DEPARTMENT OF TRANSPORTATION

Contract #: 04-0120F4Cty: SF/ALA Rte: 80 PM: 13.2/13.9File #: 69.25B**QUALITY ASSURANCE -- NON-CONFORMANCE REPORT****Location:** Changxing Island, Shanghai, P.R. China**Report No:** NCR-000858**Prime Contractor:** American Bridge/Fluor Enterprises, a JV**Date:** 10-Oct-2010**Submitting Contractor:** Zhenhua Port Machinery Company, Ltd (ZPMC), Changxing Island**NCR #:** ZPMC-0820**Type of problem:**

Reference Description: QA found 2 missed UT indications after ZPMC had tested and accepted these weld in bikepath assembly BK004A5

Subject: NCR No. ZPMC-0820

Report No: NCR-000840

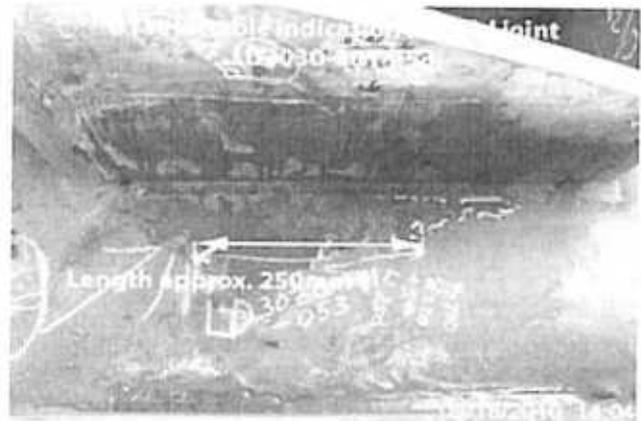
During the Quality Assurance (QA) Ultrasonic Testing (UT) review of welds located on Orthotropic Box Girder (OBG) segment 13BE and 13CE, this QA Inspector discovered the following issues:

- Three (3) longitudinal linear class "A" rejectable indications measuring approximately 180mm~260mm in length.
- The welds are identified as LD3028-001-031, LD3027-001-026 and LD3030-001-053.

- Material thickness for all joints is 30mm.
- The indication db rating for joint LD3028-001-031 is a +6.
- The indication db rating for joint LD3027-001-026 is a +4.

- The indication db rating for joint LD3030-001-053 is a +5.
- The depth of the indications are from 20mm~23mm deep.
- The Weld LD3028-001-031 is joining longitudinal diaphragm (X3682A) to lifting Lug.

- The Weld LD3027-001-026 is joining longitudinal diaphragm (X3684B) to lifting Lug.
- The Weld LD3030-001-053 is joining longitudinal diaphragm (X3685A) to lifting Lug.

- All Welds are Complete Joint Penetration (CJP) "T" joint.
- All welds are Seismic Performance Critical Members (SPCM).
- The Y distance for joint LD3028-001-031 is 110mm from bottom cope hole.

- The Y distance for joint LD3027-001-026 is 40mm from bottom cope hole.
- The Y distance for joint LD3030-001-053 is 700mm from bottom cope hole.
- The indications are clearly marked on or near the weld.

These welds were designated to be PJP welds and no UT is required. The NWIT were submitted due to the internal fault between the floor QC & NDT operator of ZPMC. ZPMC is providing the MT records to show the acceptance of these welds and is requesting closure of this NCR.

Report No: NCR-000847

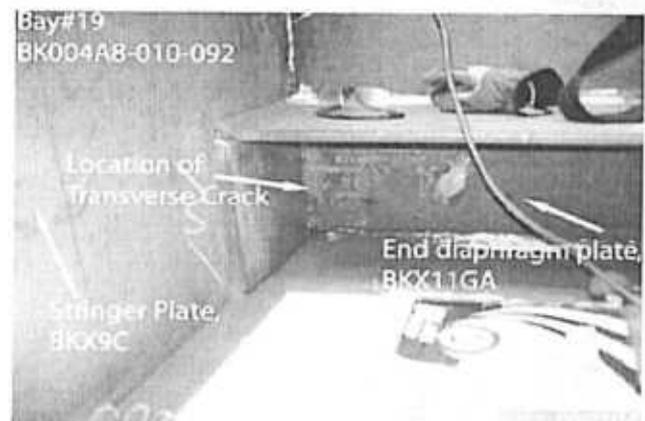
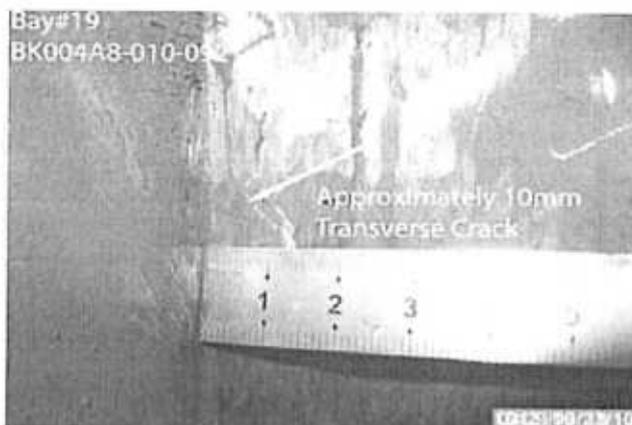
During the Quality Assurance (QA) Magnetic particle Testing (MT) review of welds located on OBG Bike path BK004A-010, this QA Inspector discovered the following issue:

- One transverse crack that measured approximately 10mm in length.
- The weld is identified as BK004A8-010-092.
- The weld is a Partial joint penetration (PJP) T joint, joining the Stringer plate (BKX9C) to the End diaphragm plate (BKX11GA).
- The Y Location is 100mm from the bearing plate.
- The OBG Bike path is located in BAY#19.
- This crack is clearly marked on the material on/near the weld.
- This weld joint is designated as Non-Seismic performance critical (Non-SPCM) weld member.
- The Notice of Witness Inspection Number (NWIT) is 006731.
- The crack is located within the area that has been re-tested and accepted by ZPMC Quality Control (QC) subsequent to the heat straightening procedure.

ZPMC acknowledged the indication was missed and has issued an internal NCR to address this problem. ZPMC has repaired the indication and is providing the NDT record to show the acceptance of this weld. Based on this, ZPMC is requesting closure of this NCR.

Report No: NCR-000849

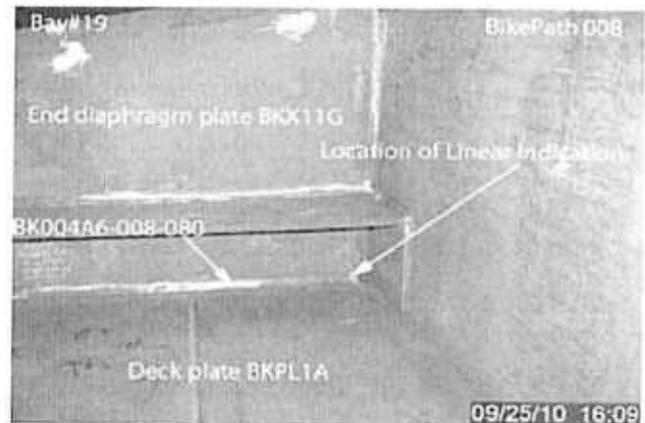
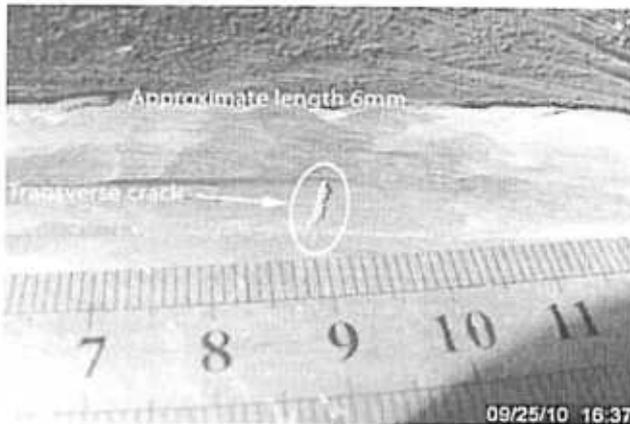
During the Quality Assurance (QA) Magnetic Particle Testing (MT) review of welds located on Bike Path 008, this QA Inspector discovered the following issues:

- One Longitudinal linear crack in the weld measuring approximately 15mm in length.
- The weld is identified as BK004A6-008-080.
- The weld is partial joint penetration (PJP), joining the End Diaphragm plate identified as BKX11G to the Deck Plate identified as BKPL1A.
- This weld joint is designated as Non-Seismic performance critical (Non-SPCM) weld member.
- The crack is clearly marked on the material near the weld.
- The OBG Bike Path 008 is located in Bay #19.

Quality Assurance (QA) Magnetic Particle Testing (MT) review of fillet welds located on OBG bike path BK004A-018, this QA Inspector discovered the following issues:

- One (1) transverse crack found on the weld measuring approximately 6mm in length.
- Y location of the indication is measured to be 2160mm.
- The crack is clearly marked on the weld joint.
- The weld is identified as: BK004A3-018-052.
- The Weld is a fillet weld joining the stringer plate (8C) to the deck plate of bike path.
- The member is located in bay 11.

ZPMC acknowledged the indications were missed and has issued an internal NCR to address this problem. ZPMC has repaired the indications and is providing the NDT records to show the acceptance of the welds. Based on this, ZPMC is requesting closure of this NCR.

Report No: NCR-000861

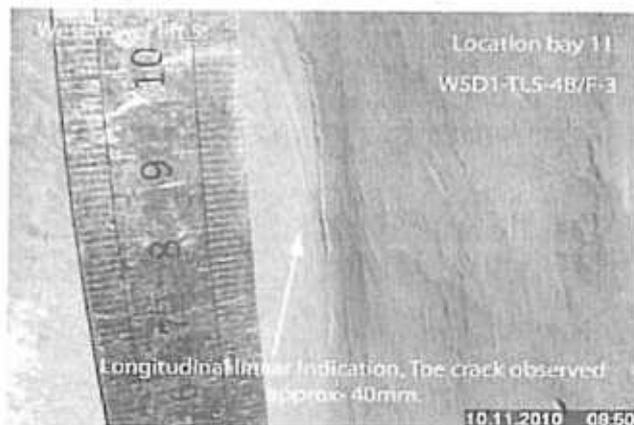
During the Quality Assurance (QA) Magnetic Particle Testing (MT) review of welds located in West Tower lift 5 Grillage plate, WSD1-TL5-4B/F-3, this Quality Assurance (QA) Inspector discovered the following issues:

-One longitudinal toe crack measuring approximately 40mm in length.

-The weld is identified as: WSD1-TL5-4B/F-3.

-The Weld is a Complete Joint Penetration (CJP) weld, joining the grillage plate to skin plate.

-The Notice of Witness Inspection Number (NWIT) is 06917. The indication is located on CJP weld area that has been previously tested and accepted by ZPMC Quality Control (QC) personnel. As per the contract documents, ZPMC's QC personnel are required to perform 100% MT inspection of this weld. The attached photographs provide additional detail.

ZPMC acknowledged the indication was missed and has issued an internal NCR to address this problem. ZPMC has repaired the indication and is providing the NDT record to show the acceptance of this weld. Based on this, ZPMC is requesting closure of this NCR.

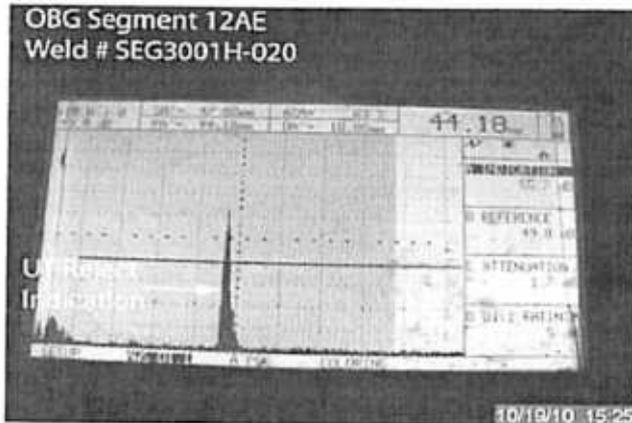
During the Quality Assurance (QA) Ultrasonic Testing (UT) verification of weld located on Segment 12AE, this QA Inspector discovered the following issue:
